DOCKET ITEM #8
Development Special Use Permit #2021-10025
TMP Special Use Permit #2021-00084
Oakville Triangle Block D Townhomes –
2610 Richmond Highway, 420 & 300 Swann Avenue

| Application | General Data | |
|---|-------------------------------|--|
| Project Name: Oakville Triangle Block D Townhomes | PC Hearing: | November 4, 2021 |
| Location: 2610 Richmond Highway, 420 & 300 Swann Avenue | Zone: | CDD #24/ Coordinated Development District #24 |

Figure 1: Open space diagram per CDD Concept Plan identifying a required 15% ground level open space for Block D.

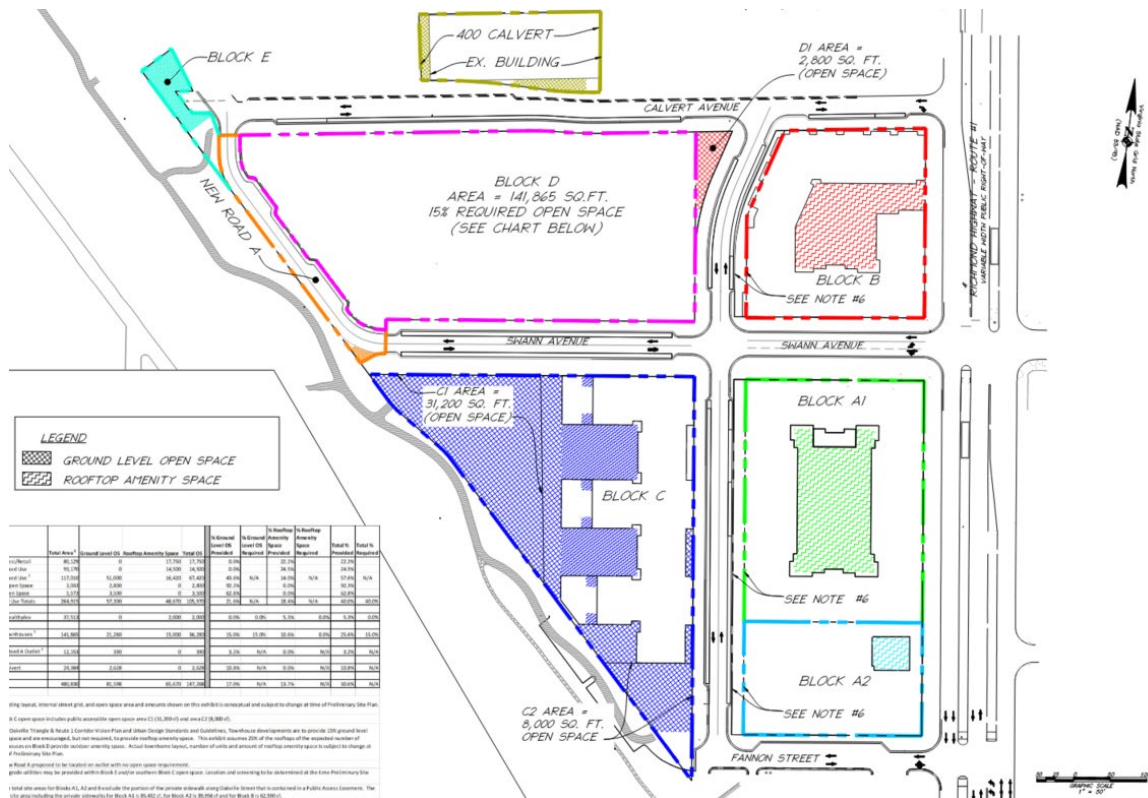
Per the CDD Concept Plan, Block D1, directly adjacent to the proposed townhomes, is to be publicly accessible open space per the overall CDD open space requirements. CDD Condition #36 requires the dedication of a perpetual public access easement across Block D1, prior to the issuance of the certificate of occupancy for the adjoining development block. As such, the applicant will be designing and installing the open space on Block D1 and will ensure the space is ready for public access with the first certificate of occupancy for the townhome site on Block D. Block D1 does not count towards the required open space for the townhome development.
